## **Leyton Properties Pty Ltd**

### **Calton Road Gawler East, Lot 9010 CT 6205/146 (Proposed lot 2044 and 2050 in DA 490/D026/19)**

490/E008/19

#### **UPDATE REPORT**

**Figure 7 – Proposed Lighting Layout**

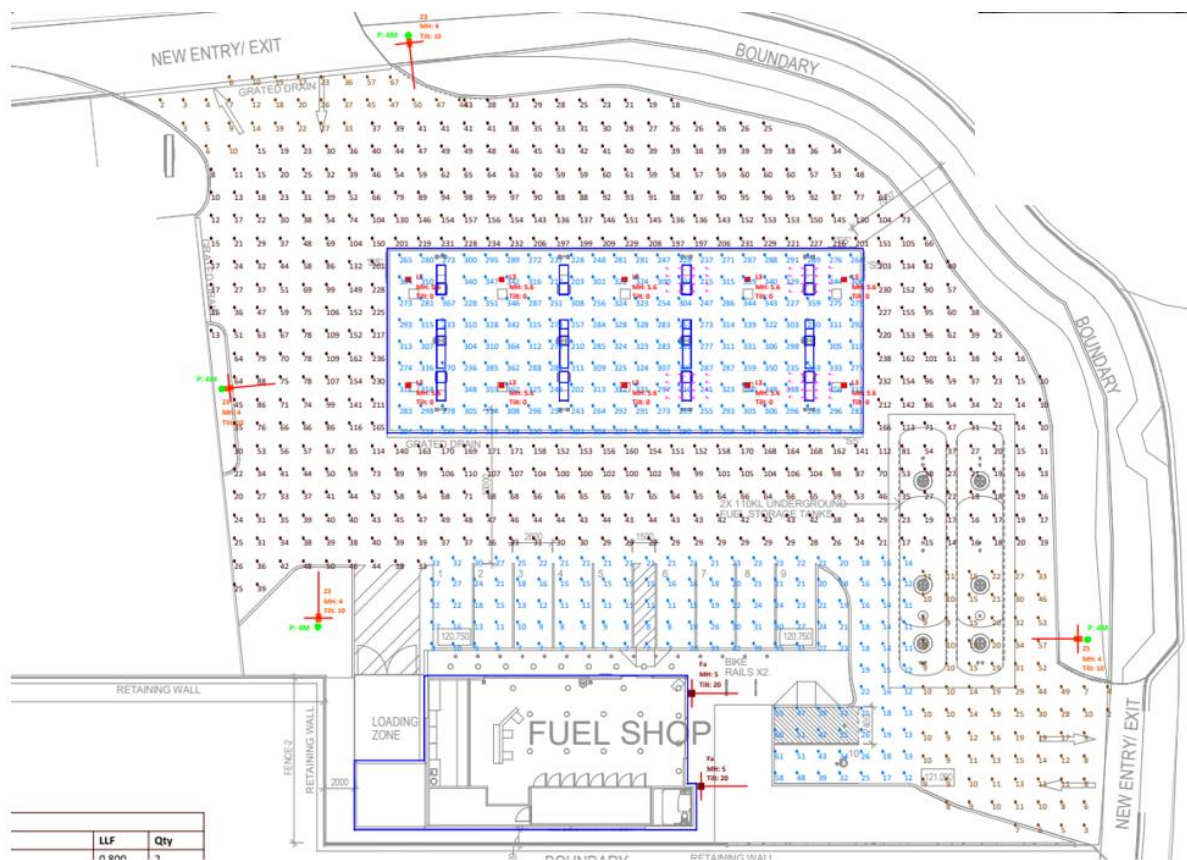
TMK Consulting Engineers were engaged to provide a lighting modelling report to address the SCAP (State Commission Assessment Panel) concerns in relation to light spill across to adjacent boundaries properties from the proposed external lighting design of described development site; and addressing the certification of lighting design to below Australian Standards;

- a) Provide certification/commentary on the light spill across the boundary lines to adjoining properties boundaries during both curfew & non-curfew hours when the site is in operation, for compliance to AS4282-2019 Table 3.1 and table 3.2 criteria (extract copied below) for Environmental Zone A2 – Low District Brightness for Rural Living Zone being the worst case scenario.

The modelled maximum spill on all boundaries for external lighting based on the above lighting layout and type complies with the criteria outlined in AS4282:2019.

**Figure 16**

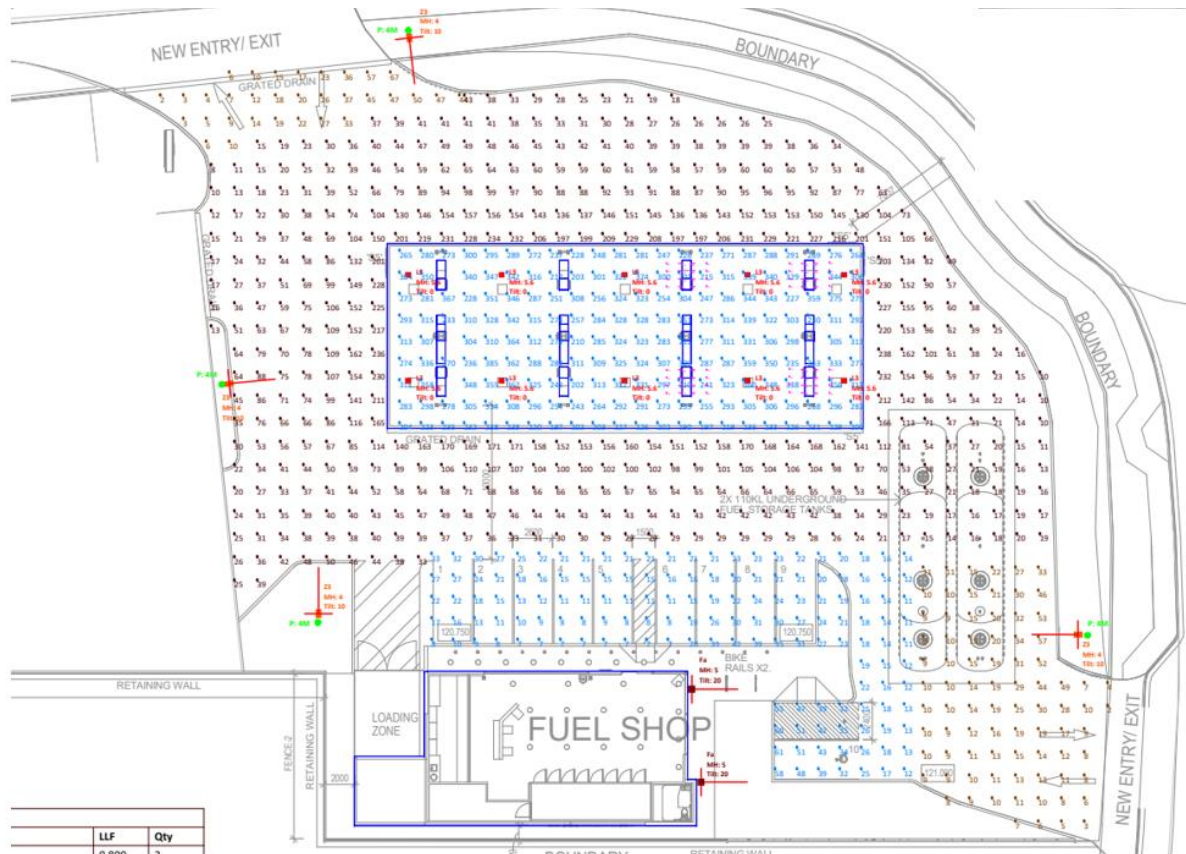
- b) Provide recommendation on the illumination level on the car park areas and driveways for compliance to AS1158.3.1 - 2020 for below usage areas indicated below and shown in Figure 6;

The modelled illumination level on ground plane on the proposed carpark (main and disabled both) based on the above lighting layout and type complies with the criteria outlined in AS1158.3.1:2020

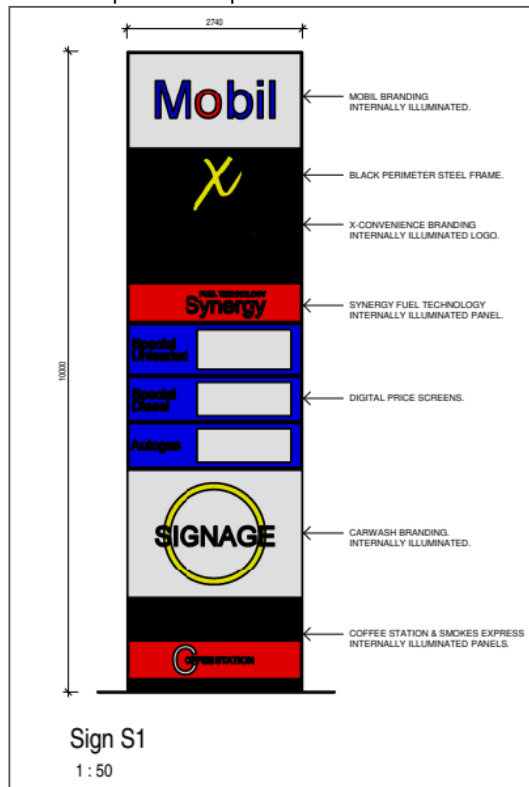
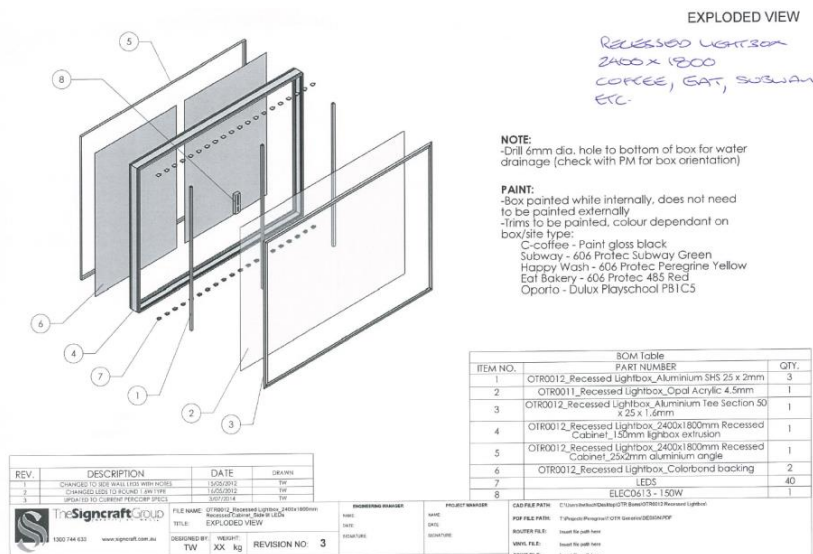
We note that the signage contractor is unable to provide the photometric data for the advertising signs at this stage.

The illuminated signs illuminated are side mounted LED strips. The led strips have a 160 degree beam angle which will provide no direct glare to the signage panel and a softer and even light to the signage box.

The brand light box will be completed with a dimmable driver Mean Well HLG -150H which will be dimmed down measured on site to ensure the *veiling luminance from the advertising signs not exceeding 0.25cd/m*.

We recommended that a dimmable controller ELEC0613-150Watt is installed for pylon signs. Pylon signs are suggested to be dimmed to meet the pre-curfew hours limited to a maximum of 5 lux across the boundary line, and the curfew hour limited to a maximum 1 lux (Light output to road way).
